ADDENDUM #3

**PROJECT: BATON ROUGE POLICE DEPARTMENT TRAINING FACILITY
CITY PARISH PROJECT NO. 21-ASC-CP-1560**

ADDENDUM NUMBER THREE (3)

Project: **Baton Rouge Police Department
Training Facility**
999 West Irene Road
Zachary, Louisiana

Sheet A4.1

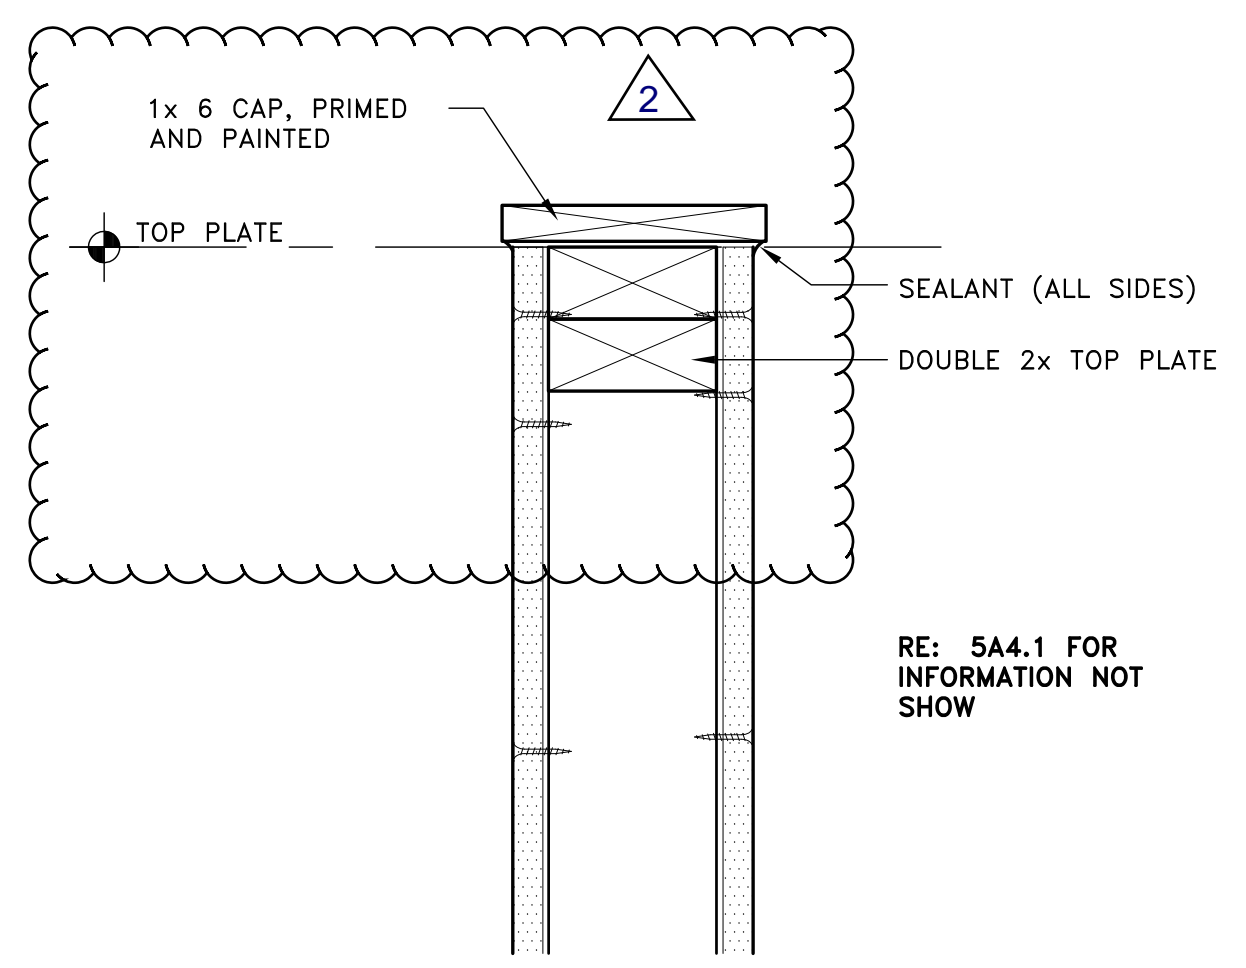
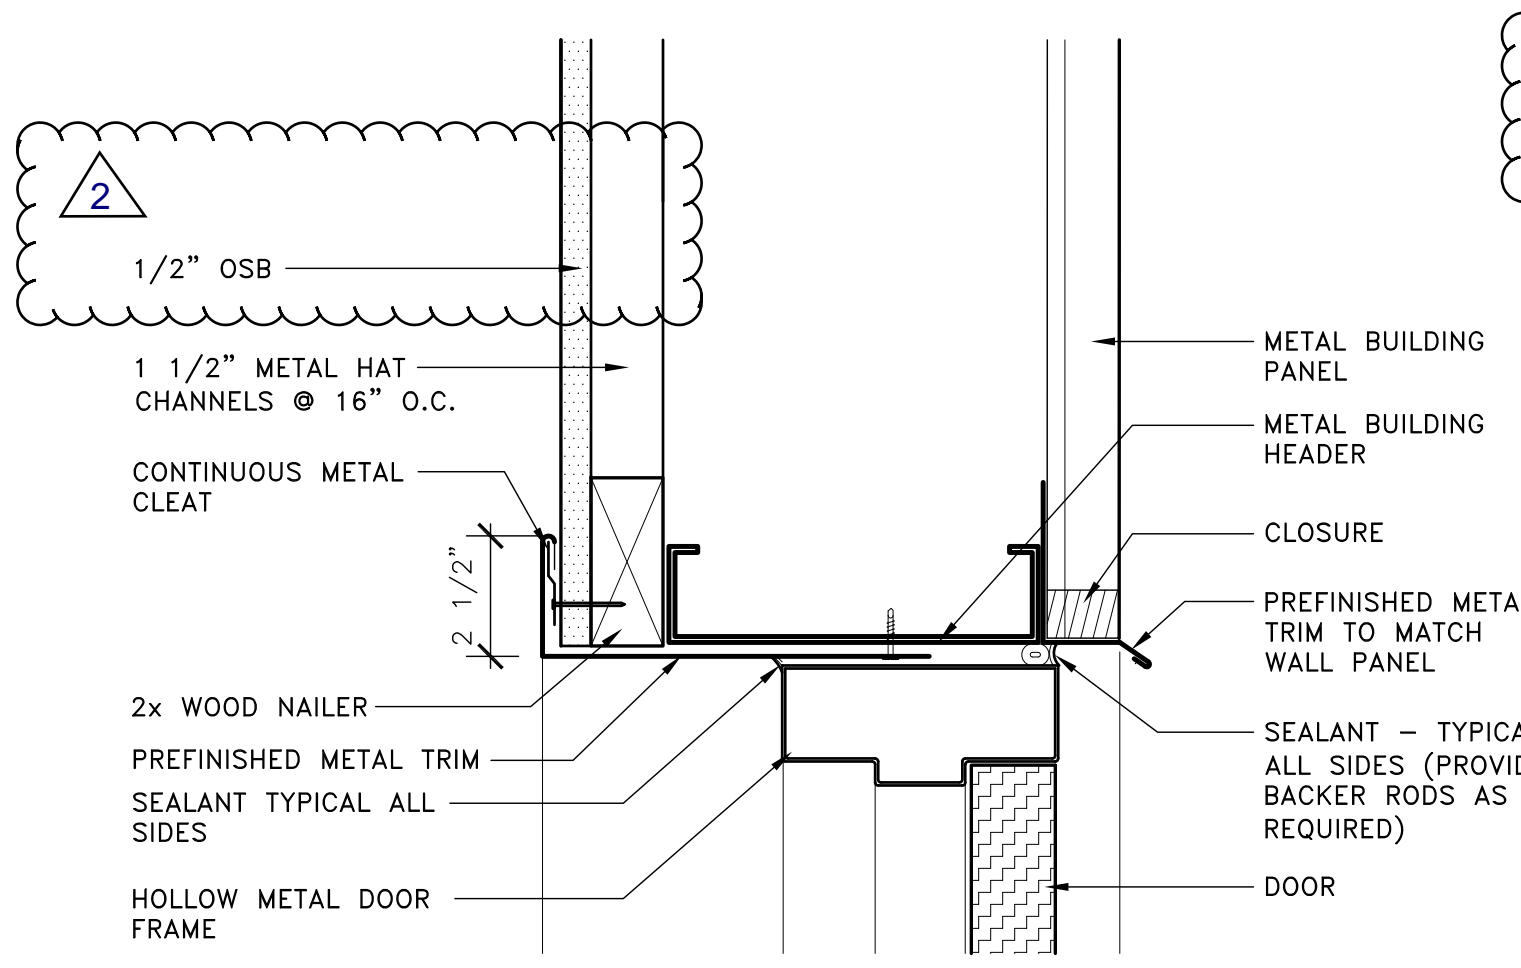
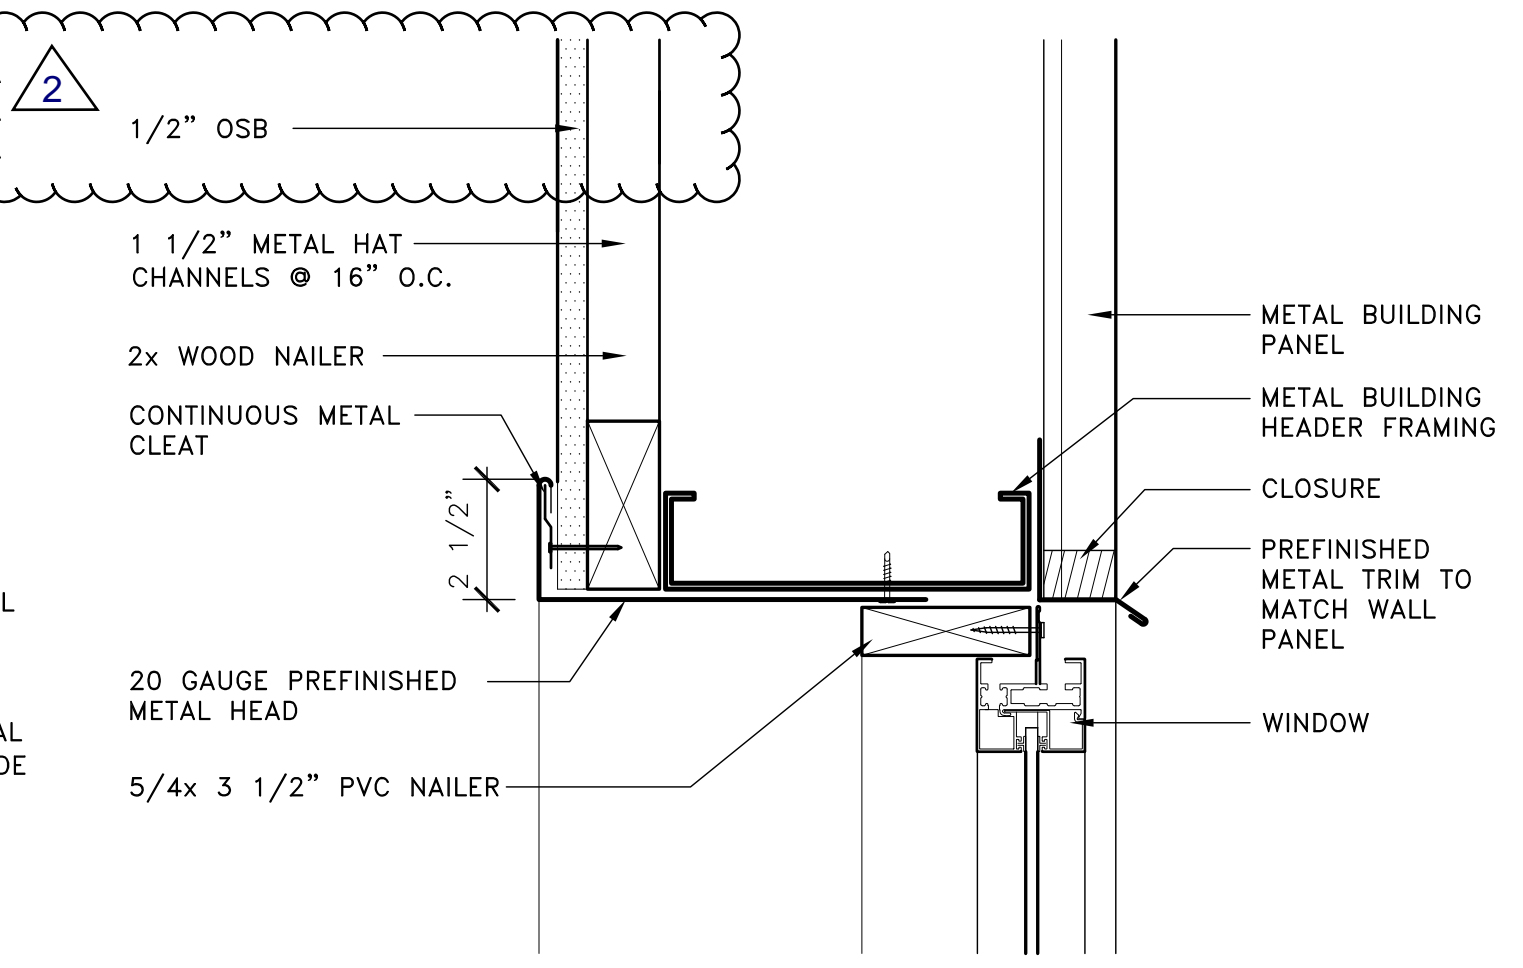
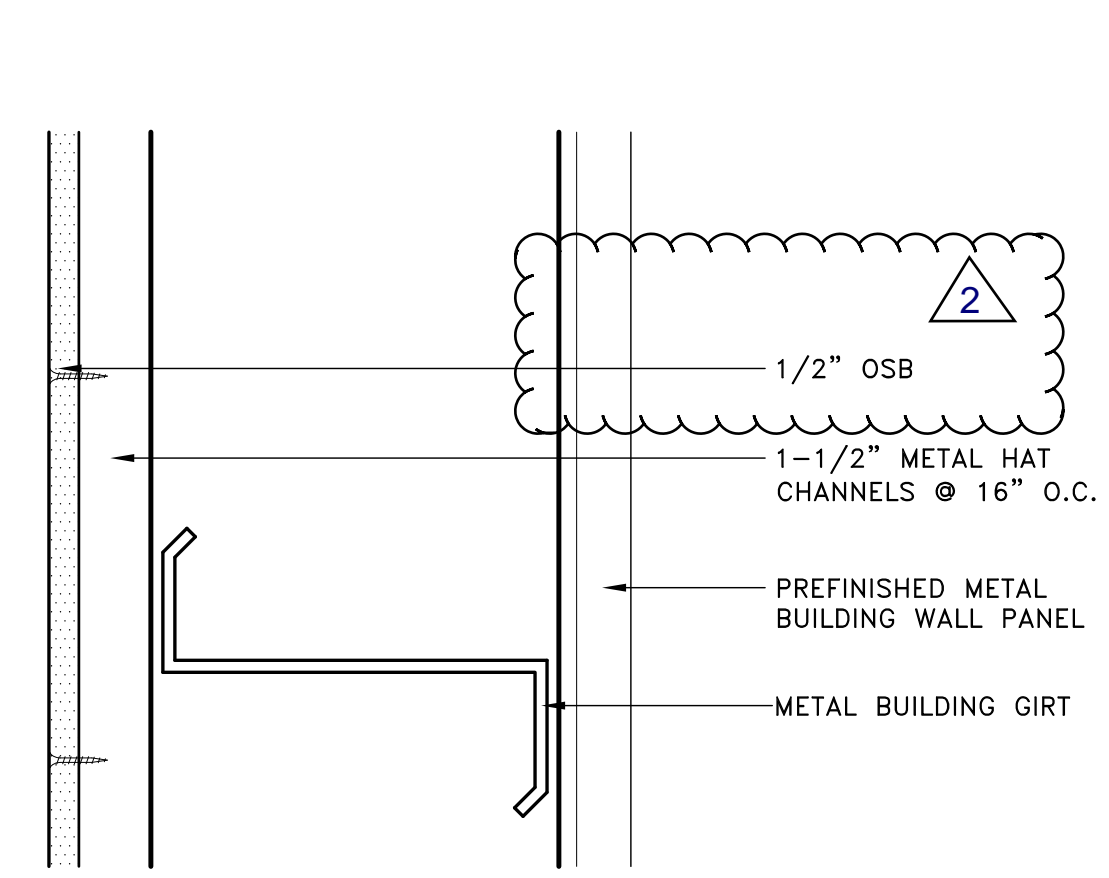
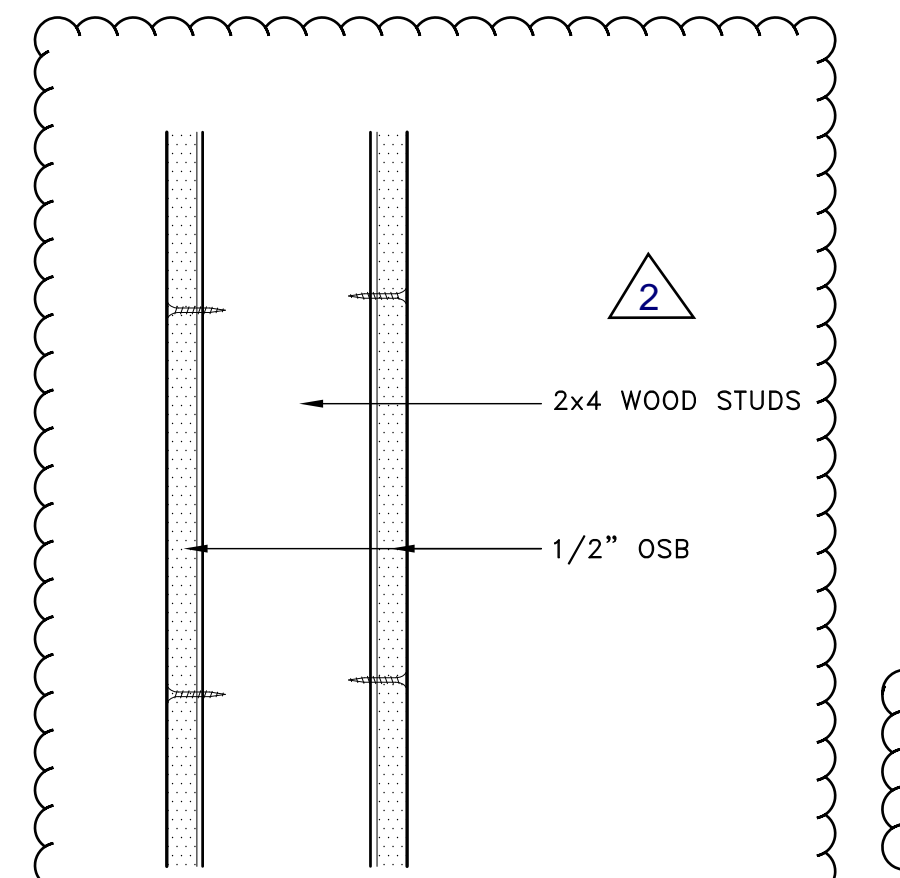
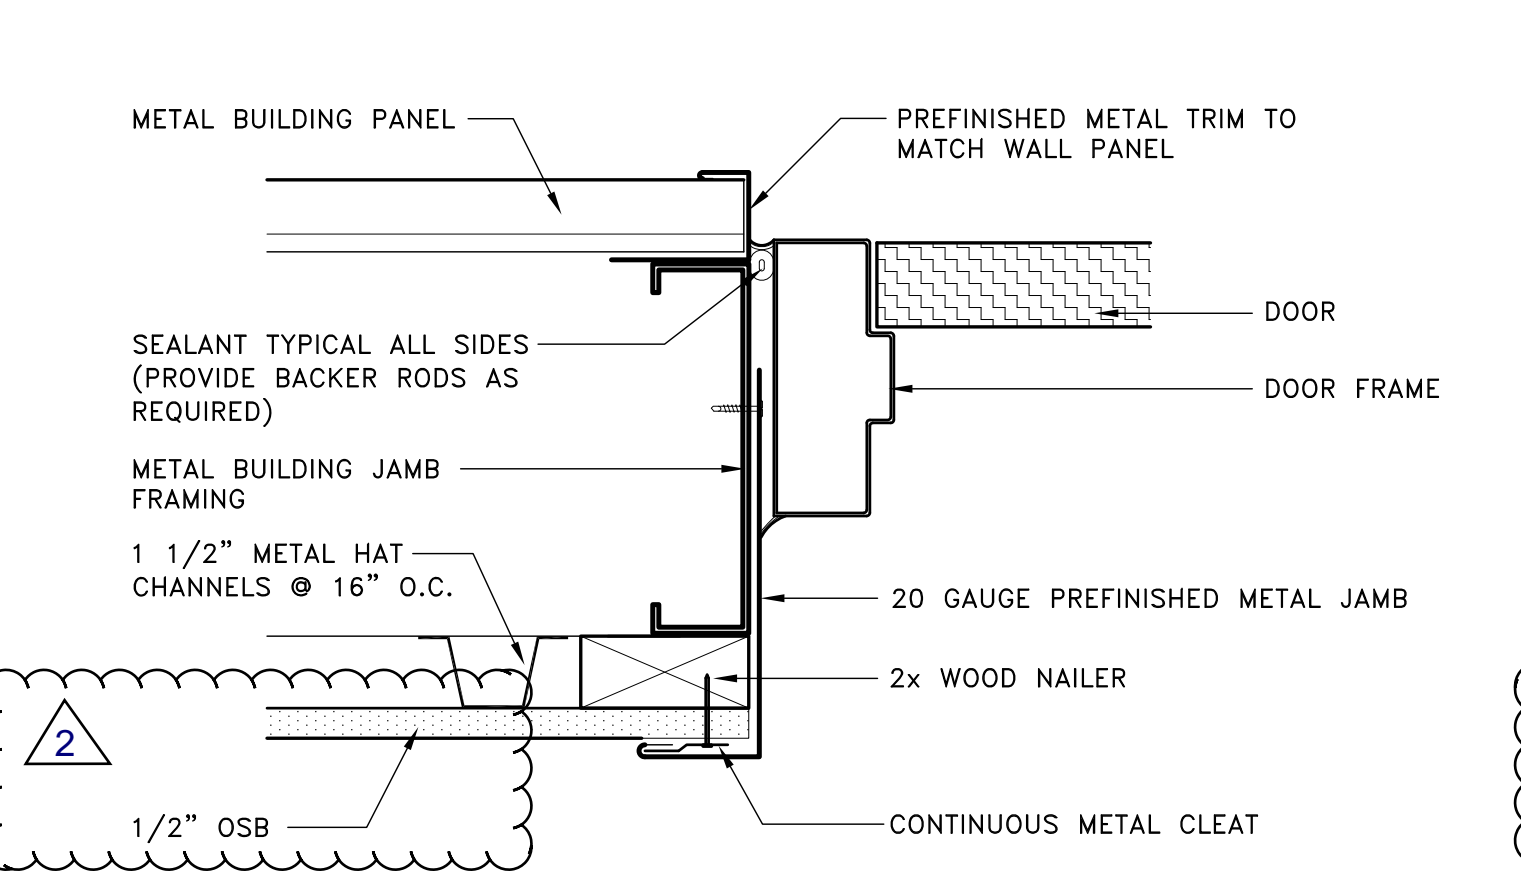
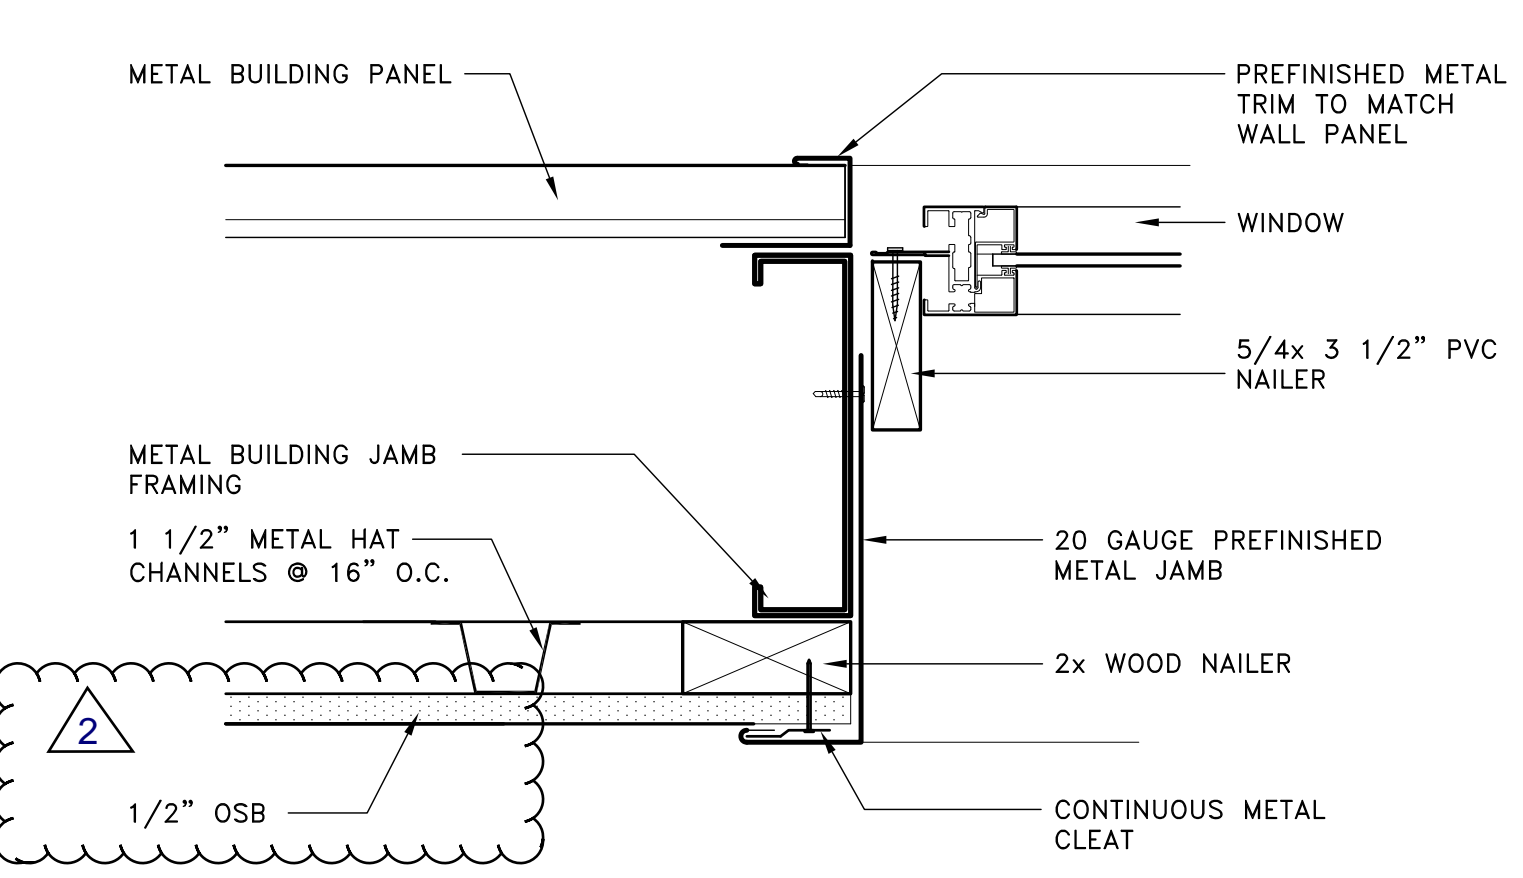
1. Delete existing sheet A4.1 and replace with new sheet A4.1 included in this addendum.
Changes include:
 - a. At interior walls, changed metal studs to 2x 4 wood
 - b. At interior walls, deleted metal wall cap in favor of painted 1x 6

- c. All interior walls changed gypsum board to OSB
